**Regulation No. 14 (Safety-belt anchorages)****Proposal for Supplement 2 to the 07 series of amendments to  
Regulation No. 14****Submitted by the experts from Belgium and Germany\***

The text reproduced below was prepared by the experts from Belgium and Germany in order to introduce prescriptions for side-facing seats in vehicles of category M<sub>3</sub> (Class II, III and B). This proposal supersedes GRSP-46-14, distributed during the forty-sixth session of the Working Party on Passive Safety (GRSP). The modifications to the current text of the Regulation are marked in bold or strikethrough characters.

Figure 1b

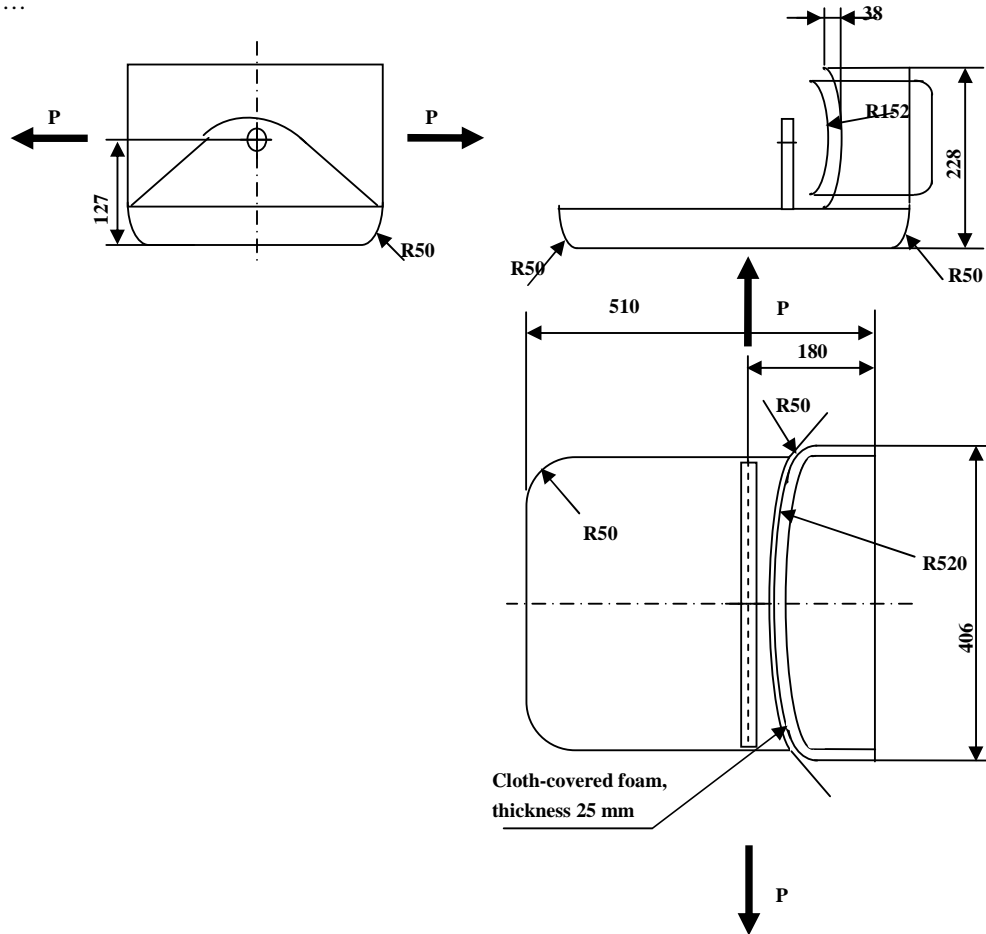
- 6.4.7.3. Traction device adapted for the test of side-facing seats is shown in Annex 5 Figure 1b.
- 6.4.8 Test of the basic structure of side-facing seats

Insert a new Figure 1b, to read:
